**SUSQUEHANNA STEAM ELECTRIC STATION  
PROPOSED LICENSE AMENDMENT NO. 285  
FOR UNIT 1 OPERATING LICENSE NO. NPF-14  
AND PROPOSED LICENSE AMENDMENT NO. 253  
FOR UNIT 2 OPERATING LICENSE NO. NPF-22  
EXTENDED POWER UPDATE APPLICATION  
REGARDING STEAM DRYER AND FLOW EFFECTS  
REQUEST FOR ADDITIONAL INFORMATION  
RESPONSES  
PLA-6176**

**Docket Nos. 50-387  
and 50-388**

**Attachment 2**  
**Non-Proprietary Version of the Request for**  
**Additional Information Responses**

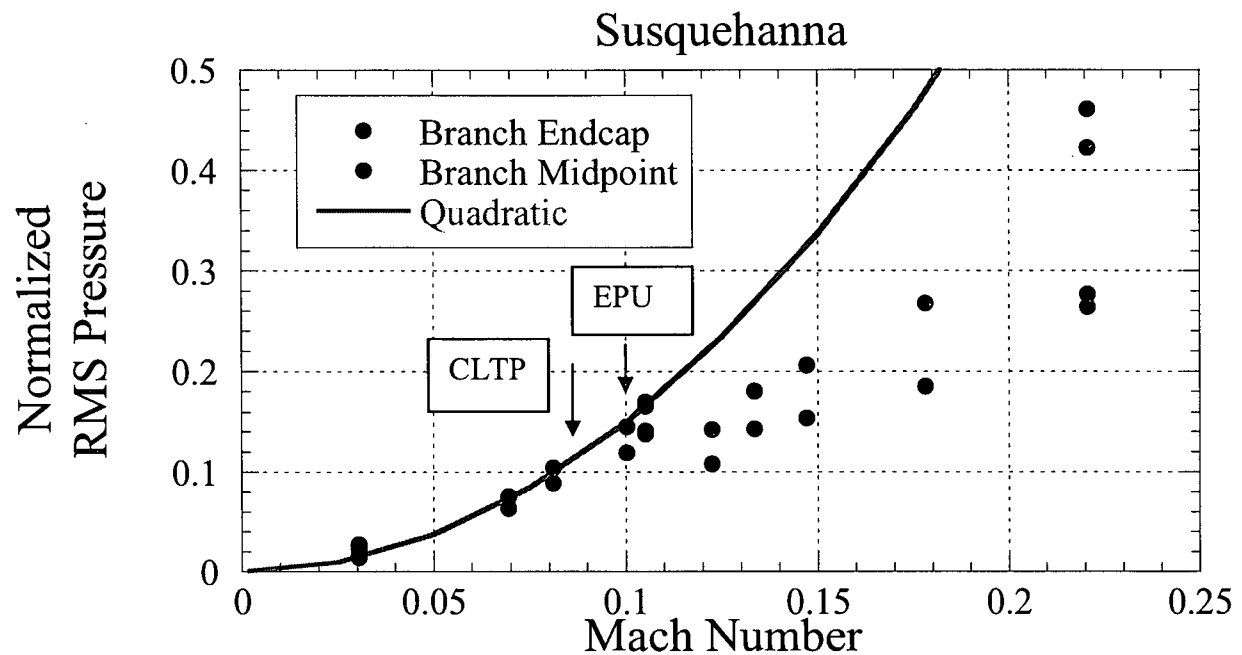
The licensee is requested to provide any available evidence which supports the assumption that pressure amplitude at low frequencies (in particular, the 15 Hz component) will continue to increase proportionally to the square of flow velocity beyond OLTP.

In addition, the 1/5<sup>th</sup> scale model testing performed by CDI, and documented in CDI Report 05-32 (Appendix 1 of Attachment 10 –Reference 1), suggests that the magnitude of the 15 Hz component will actually drop above EPU Mach number (see attached Figure 7-1).

**Figure 9-1 - Pressure data collected on main steam line A (upper location) at Susquehanna (converted from strain gage data), prior to application of coherence to reduce noise. Top: A typical time segment from 30 to 40 seconds is shown; bottom: the PSD.**

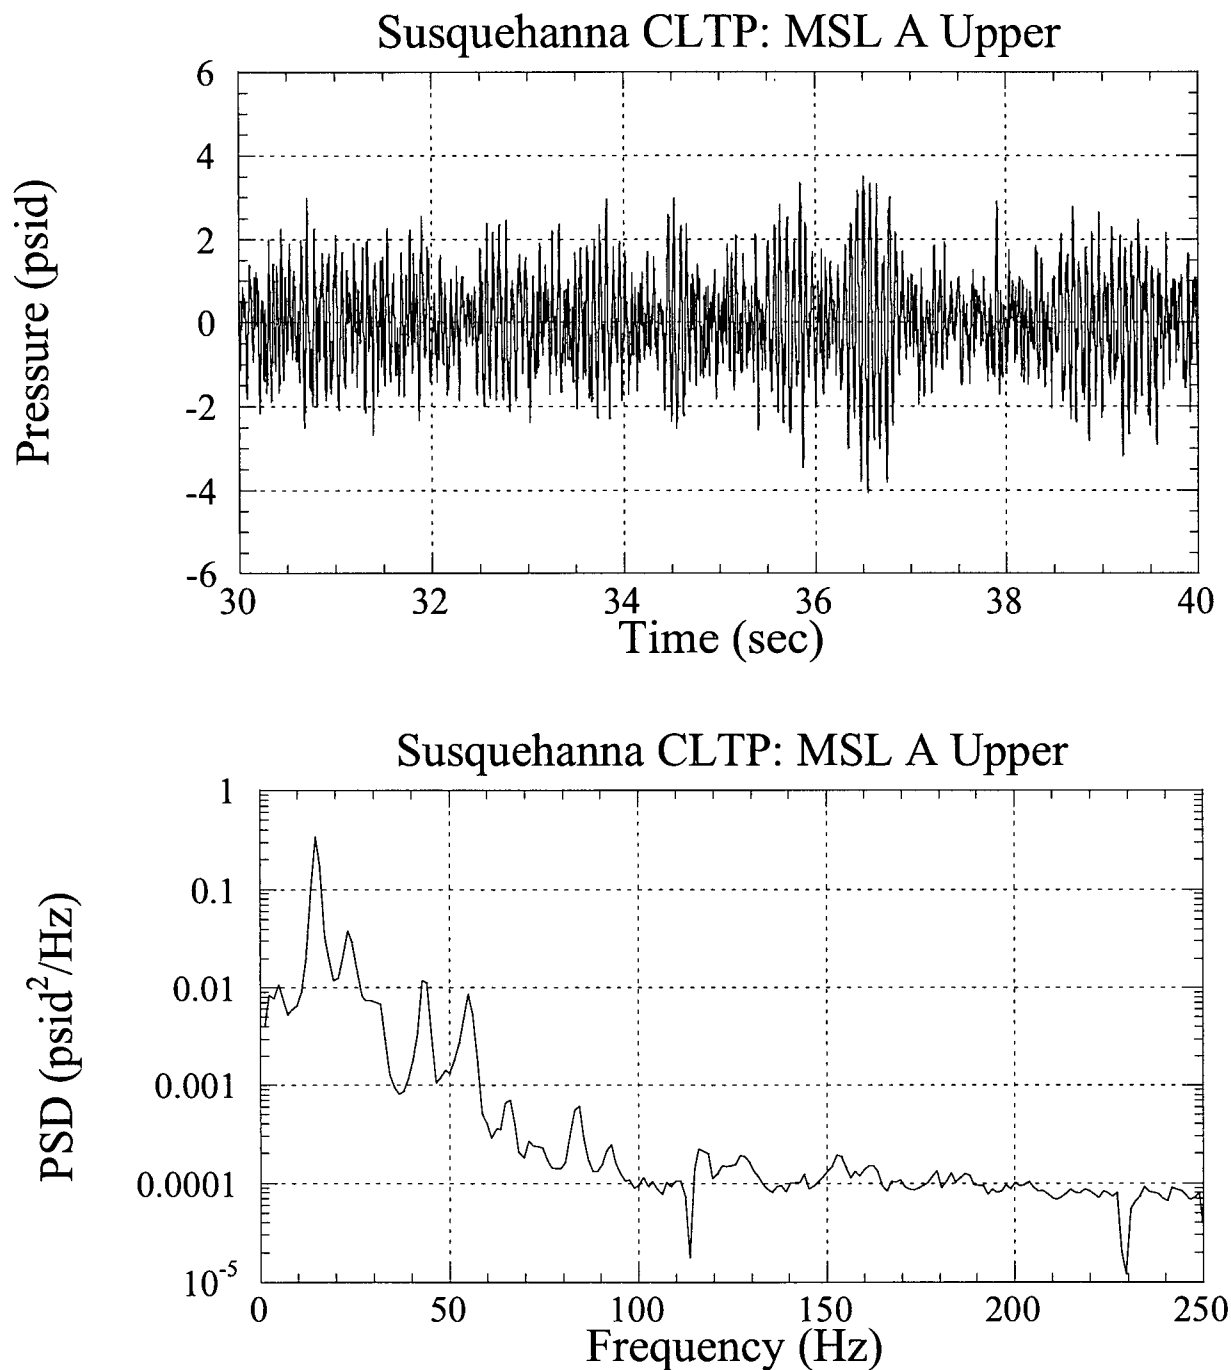
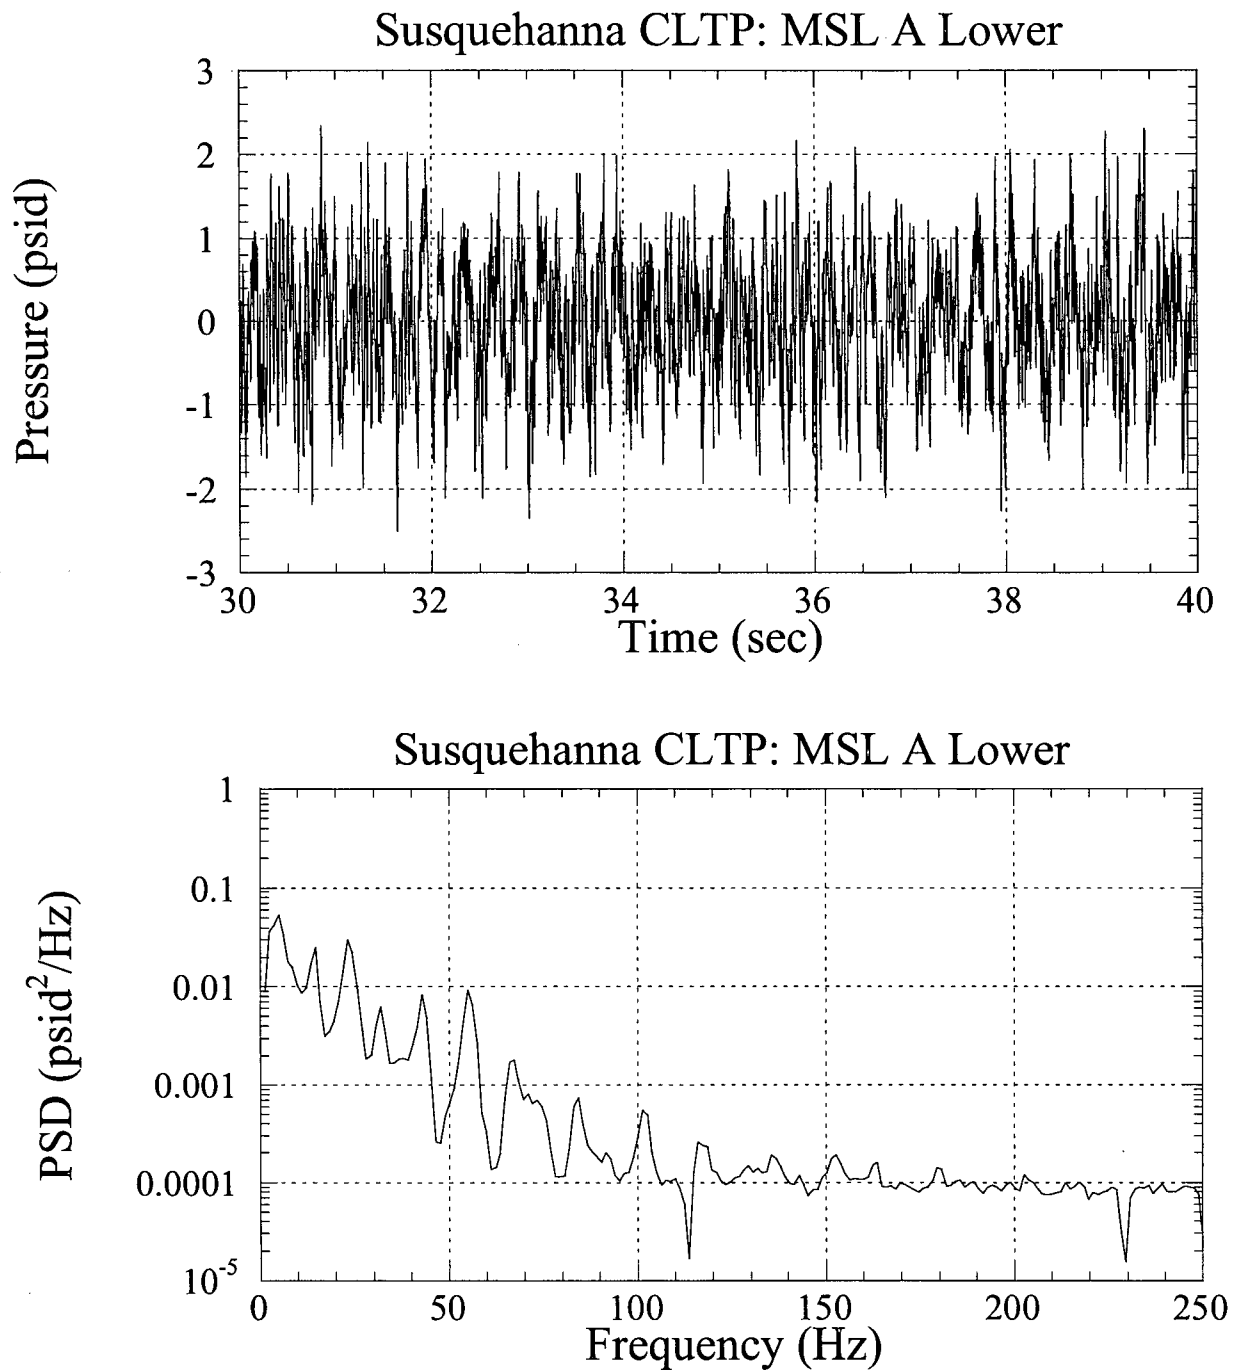
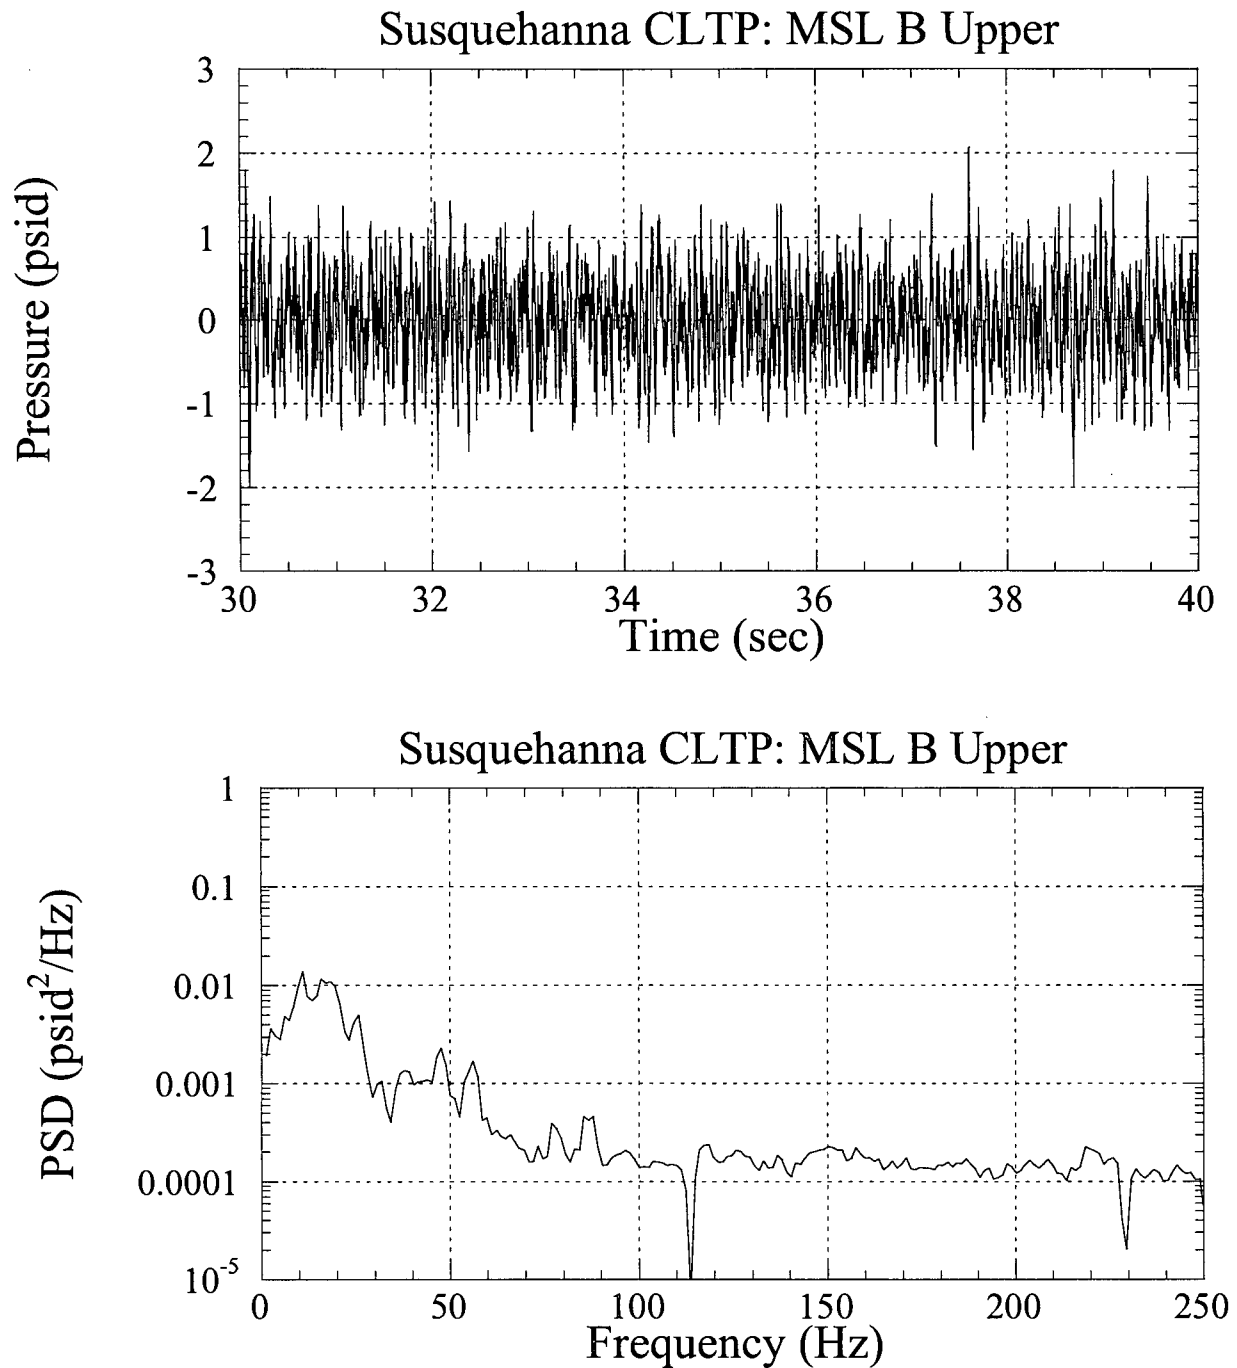
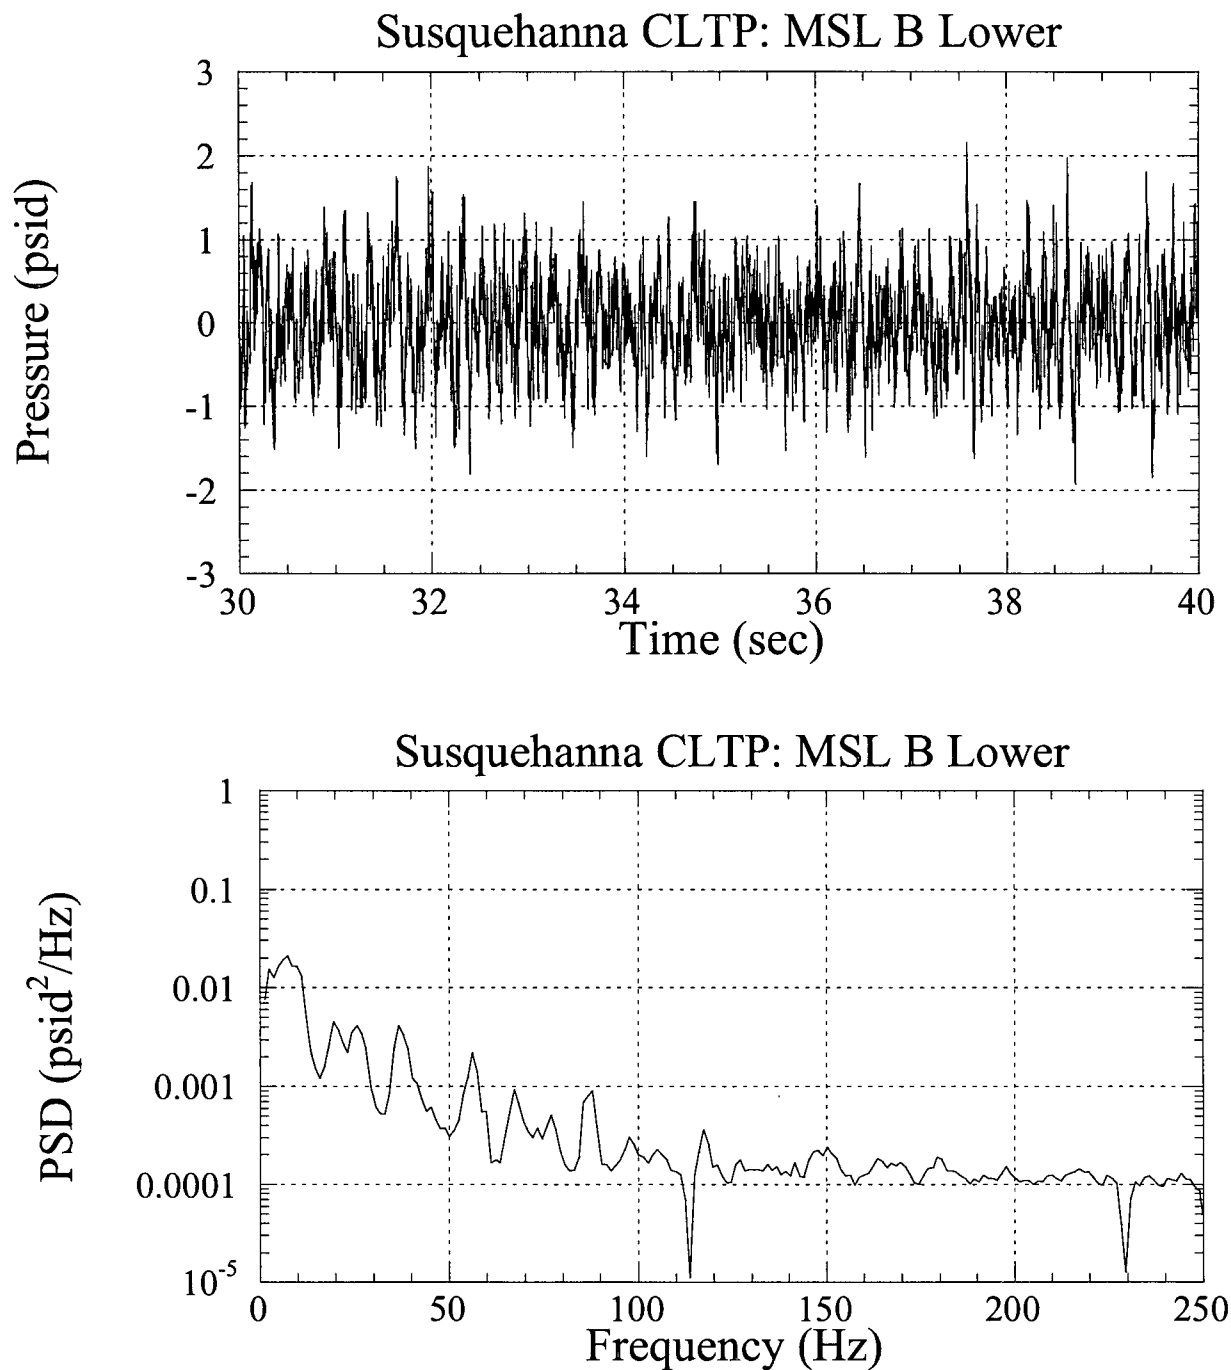
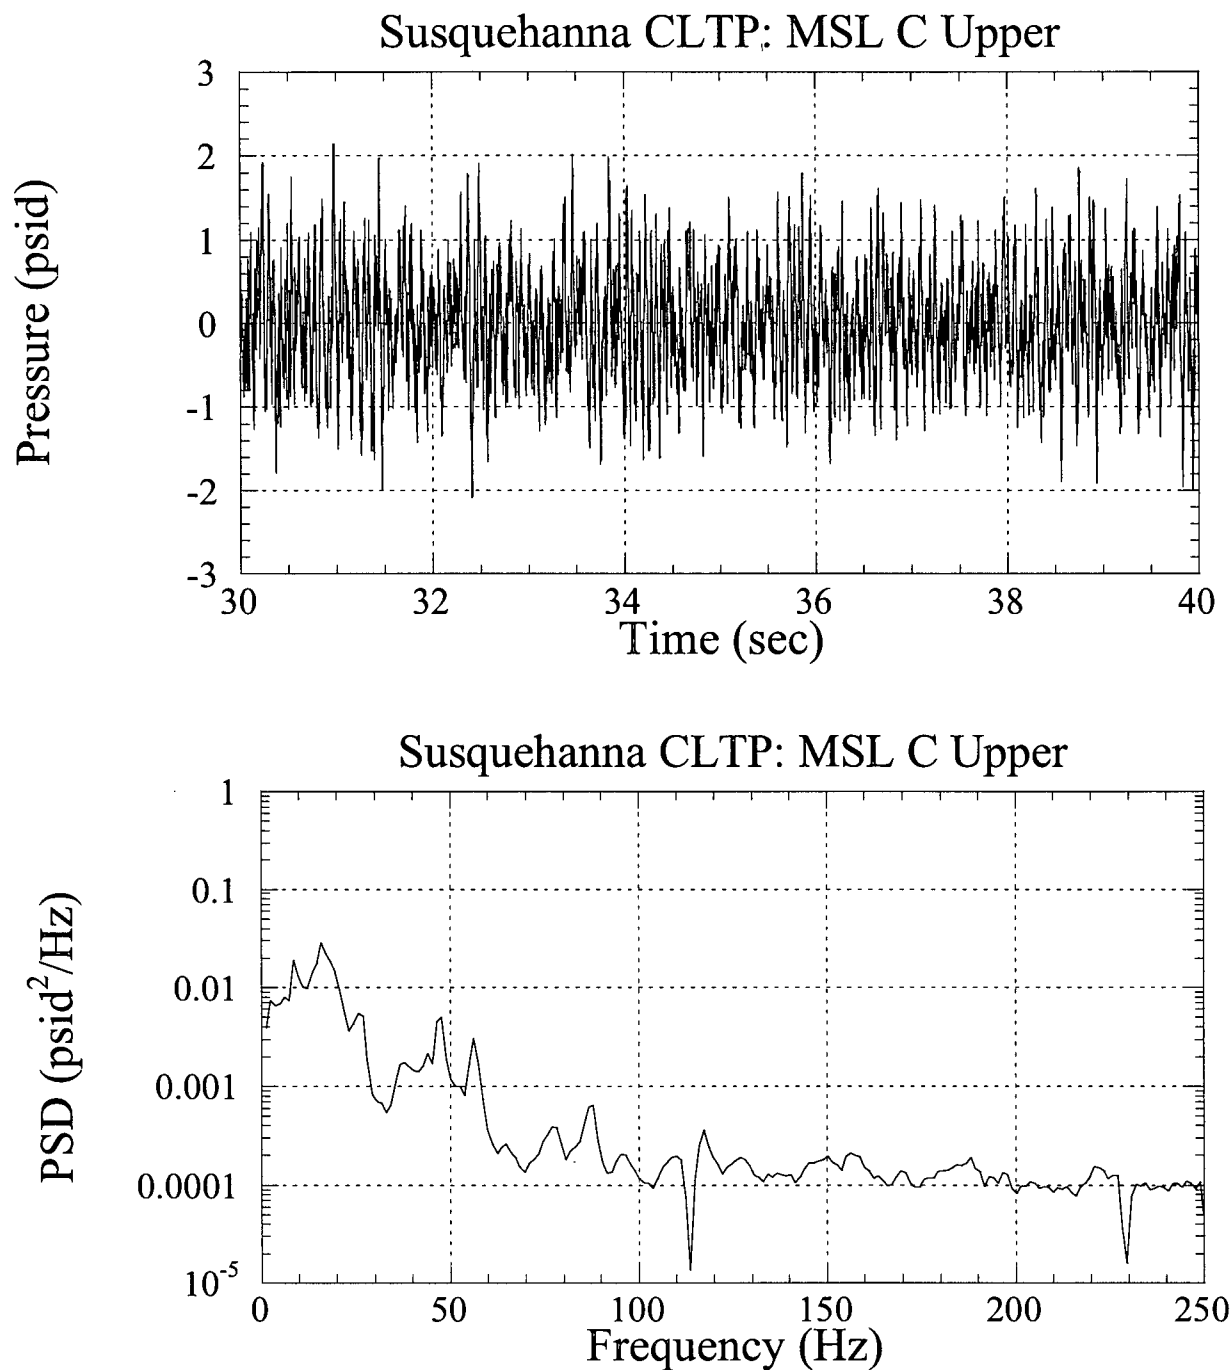
With regard to CDI 06-22, the licensee is requested to provide samples of unfiltered strain gage time signals and power spectral densities. In particular, the provided samples should include the worst case of signal to noise ratio and any other signals experiencing saturation problems or poor frequency response.

The attached Figures 9-1 through 9-8 provide the unfiltered pressure time histories and PSDs at CLTP conditions.
